Town Planning and Project Services

RE: RESPONSE TO INFORMATION REQUEST – DEVELOPMENT APPLICATION FOR A MATERIAL CHANGE OF USE (DWELLING HOUSE, ANCILLARY SHED AND HOME BASED BUSINESS) OVER LAND AT 129 RYKERS ROAD, CAPE TRIBULATION, MORE FORMALLY DESCRIBED AS LOT 2 ON RP732553

Council ref: MCUC 2026_5939/I

① SITE PLAN - OVERVIEW
1 : 5000

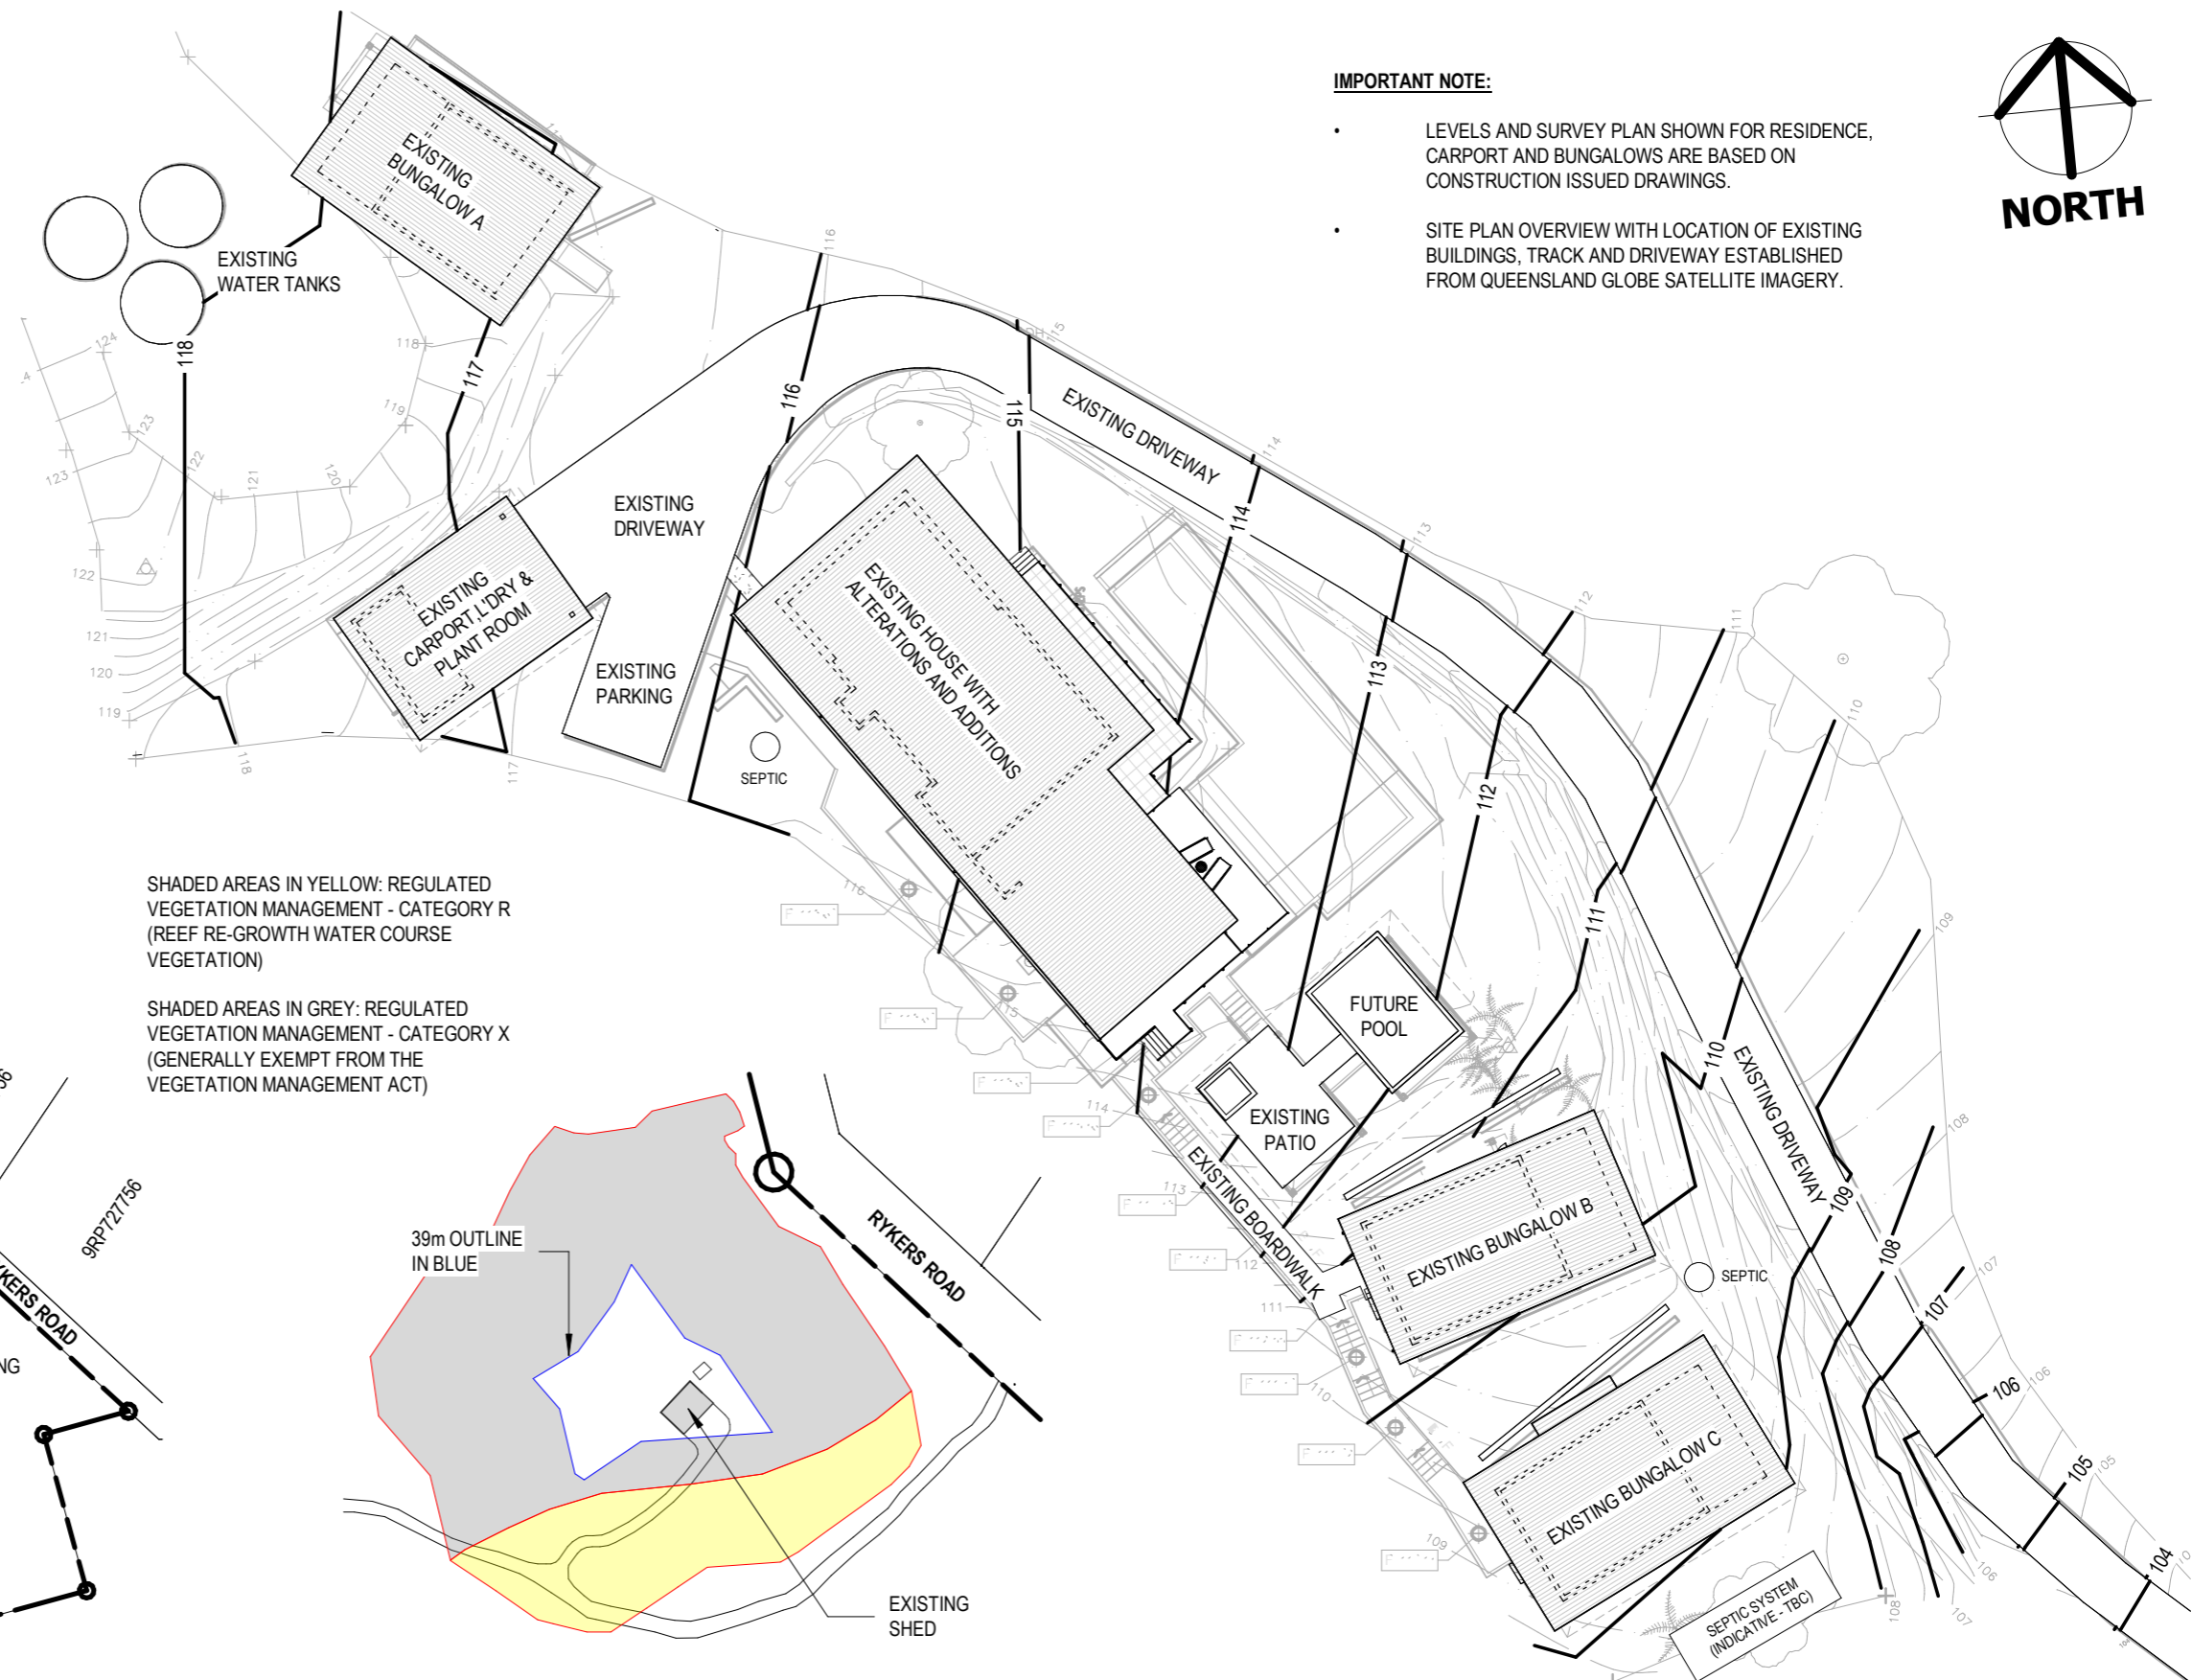
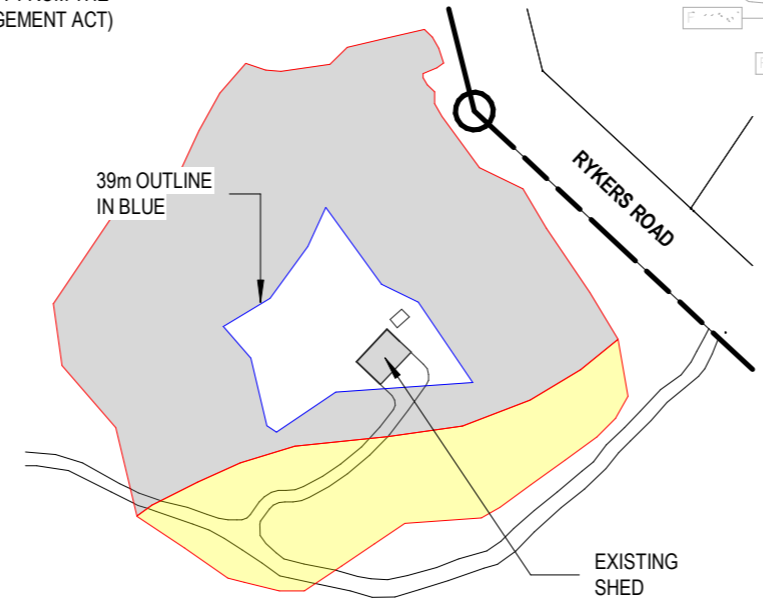
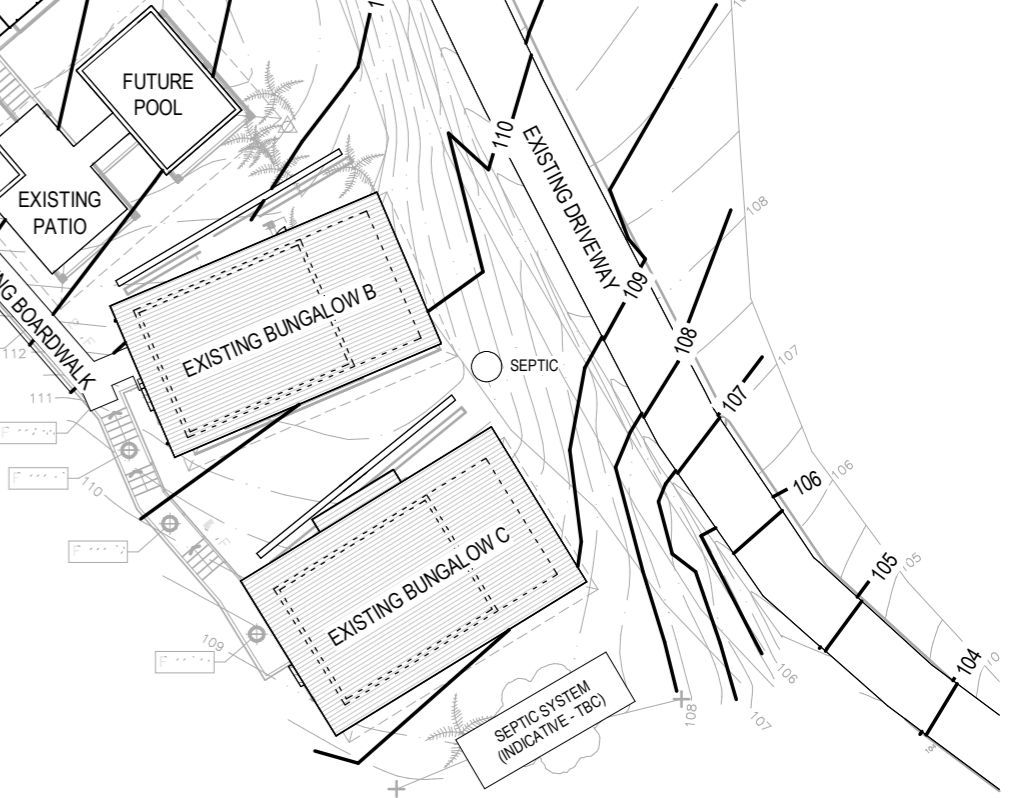
As outlined in the application material, the proposed plans include a Caretaker's accommodation which has not been applied for as part of the development application.

Advice Note: Council Officers acknowledge that the cover letter specifies that a Caretaker's accommodation use is not being applied for as part of the development application however the proposed plans do not reflect this.

To remove any ambiguity, the applicant is requested to remove the Caretaker's accommodation from the proposed drawings or alternatively clearly notate the proposed drawings to make it clear that the Caretaker's accommodation does not form part of the development application or the proposed drawings.

We confirm that it is not the intention of the Development Application to seek approval for the Caretakers Accommodation. To make this explicitly clear the Drawing Set has been revised to remove the Caretakers Accommodation, and is included under Attachment 1.

Photo 1:
20 metre section of driveway (715 metre long driveway) impacted by Cyclone Jasper exceeding 1 in 100 year water volumes, producing landslip which provides an opportunity to improve the driveway drainage.

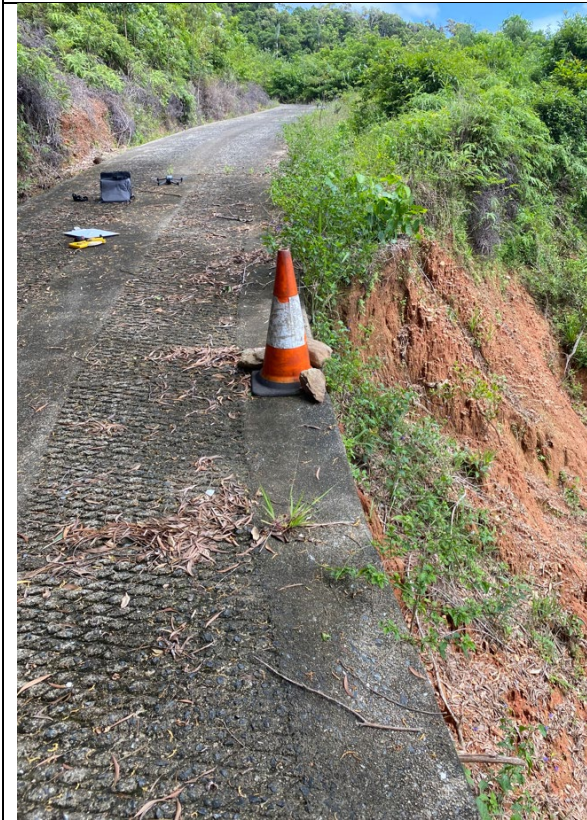
Council Officers note that the hillside supporting the existing concrete driveway at CH108 has been significantly impacted by a landslip event however the application material does not provide any engineering design or technical reporting to identify how this landslip will be managed.

The Applicant advises that the affected section of driveway forms part of an existing access driveway that was originally constructed approximately 18 years ago and remained functional following the extreme rainfall and landslip events associated with Severe Tropical Cyclone Jasper in December 2023. The proposed works comprise emergency remediation and repair of a localised section of the existing driveway that was damaged during this event.
